STAFF CASE REPORT TO PLANNING COMMISSION

Subdivision Name:	A.A. Bowmans Subdivision Lots 3 thru 6 Variance Request-Minimum Suburban Infill Lot Frontage-Lot 6	PC Meeting Date: 09-08-14
Applicant Request:	Variance-Section 38-44 of the Chattanooga Zoning Regulations	
	(7) Minimum Suburban Infill Lot Frontag	e
Property Location:	8307 Igou Gap Road	
Property Owner:	Sterling Jetton	
Applicant:	MAP Engineers	
Total Acreage:	3.02 Acres	
Proposed Density:	0.99 dwelling units per acre	
Tax Map Number:	159F-B-023	
Zoning:	R-1 Residential Zone	
Staff Recommendation:	DENY

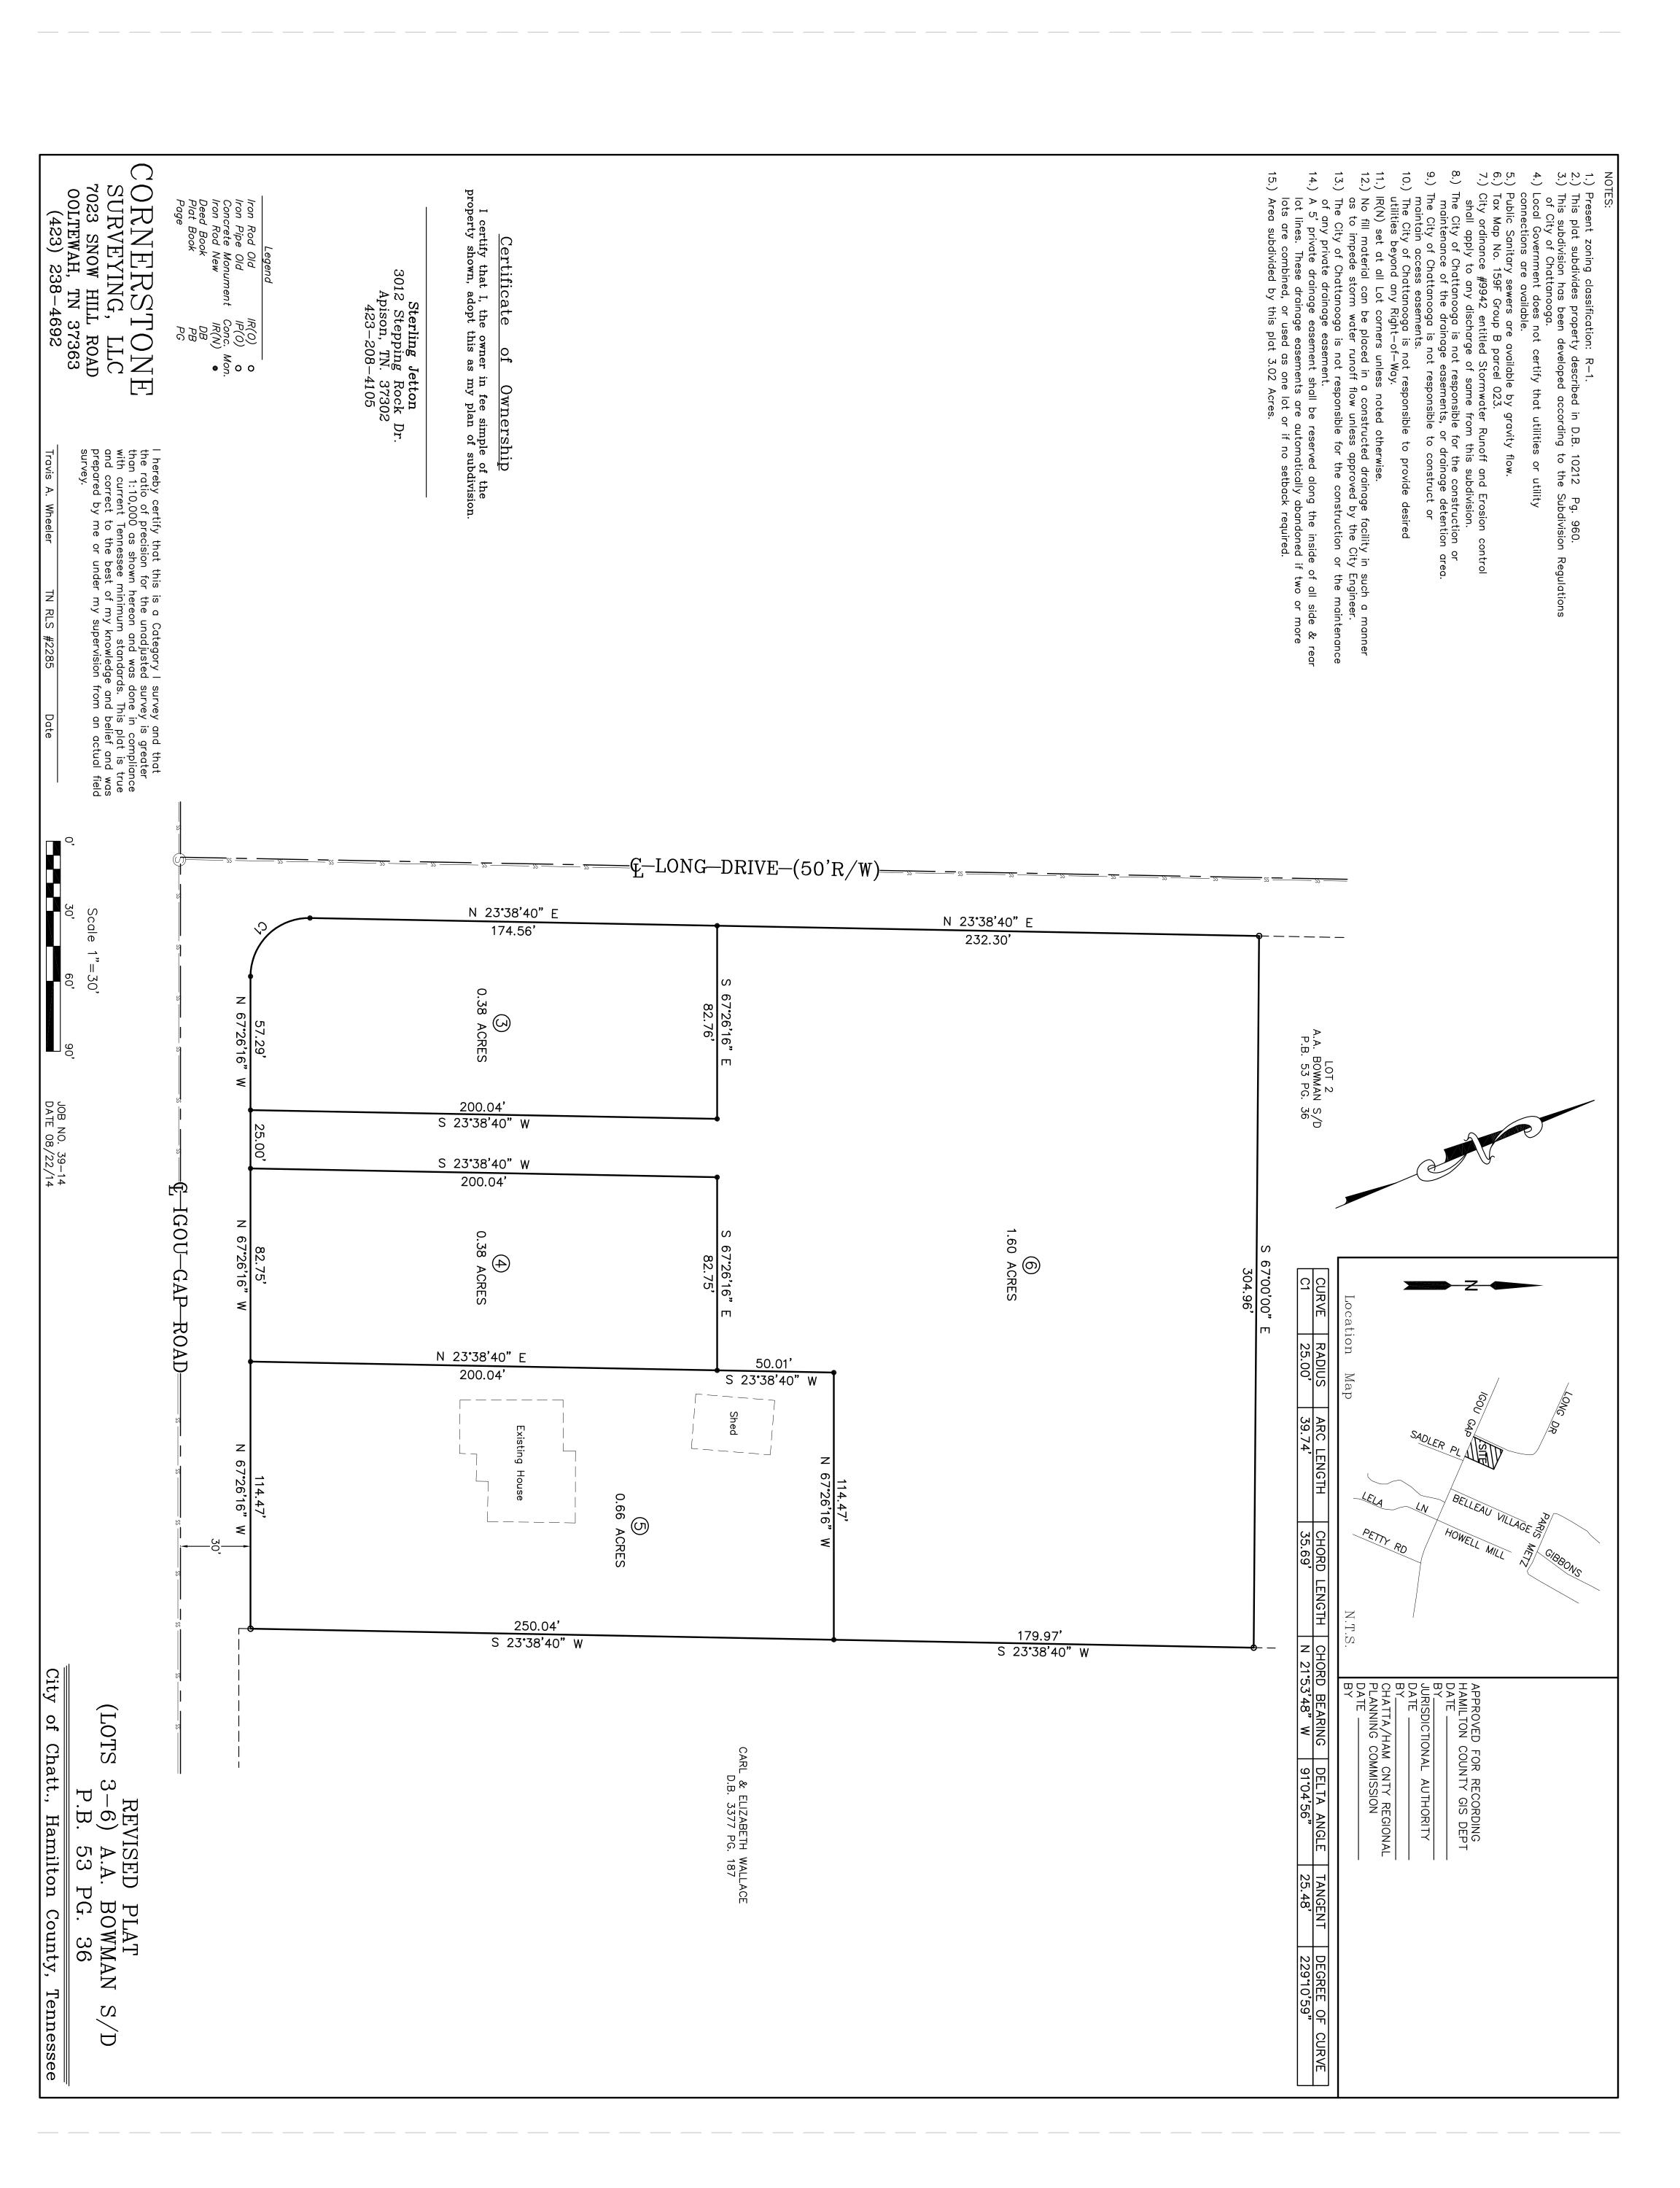
- Directly across the street from this development, 8310 Igou Gap Road RPA staff reviewed a similar request to permit a subdivision of property into two lots with each lot having approximately 25' of lot frontage along Igou Gap Road. RPA staff recommended to deny the request for the following reasons:

- Approval of the variance would permit development which does not exist or is permitted to exist.
 - o There are no flag lots on Igou Gap road within 300' of the two proposed flag lots.

- The two 25' flag stems are approximately 800' and 1,200' long. Providing fire protection to any dwelling would be difficult if the driveway is not paved and constructed to a standard to permit access for large fire equipment.

- 2. The Chattanooga-Hamilton County Regional Planning Commission approved the variance request.
- 3. At the July 14th Chattanooga-Hamilton County Regional Planning Commission meeting the Planning Commission denied the applicants request for a variance for Suburban Infill Lot Frontage for proposed Lots 3 thru 5. There was opposition present at this meeting. The discussion centered around the precedent that would be set for granting variances and establishing a new minimum lot frontage within this area of 63' if this subdivision plat was approved and recorded with 63' of lot frontage.

- 4. Based on Hamilton County GIS, the total lot frontage along Igou Gap is approximately 305. The applicant intends to keep the existing house on a separate lot (Lot 6). Taking out the lot frontage of Lot 6, which is 114.47' the applicant will have approximately 200.7'. Using the minimum required lot frontage of 79' the applicant did revised the proposed subdivision layout to reduce the number of lots from five (5) to four (4).

- 5. There does not appear to be any unusual or physical condition present that would cause impractical difficulty or hardship with complying with the minimum lot frontage of 79'.

- 6. Approving the variance will be in conflict with the intent and purpose of these regulations. The intent of the Suburban Infill Lot Frontage is to create lots that are compatible with adjoining lots. The lot frontages of existing lots on either side of the property being subdivided are 100' and 230'. Excluding the existing flag lots, the lot frontage across the street range in size from 79', 86', 115' and 165'.

Staff recommends to deny the applicant's request for the variance.

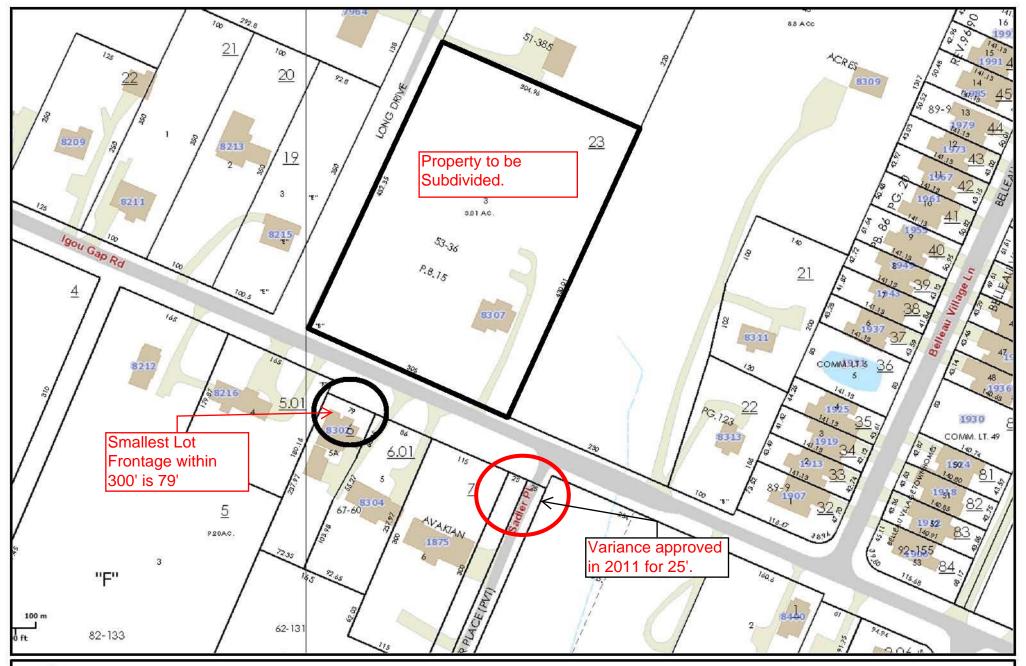
Any potential subdivision of the property must include discussions concerning proposed Lot 6. As it stands today, Lot 6 does not have lot frontage along an existing public road built. Before a subdivision plat can be approved for this site discussions need to occur between the developer and Transportation Department concerning required improvements within the right-of-way of Long Drive.

Options for discussion include the following:

- Construct a city street, to city standards all the way through to Long Drive.
- Provide a cul-de-sac with an asphalt or concrete bicycle/pedestrian connection to Long Drive.
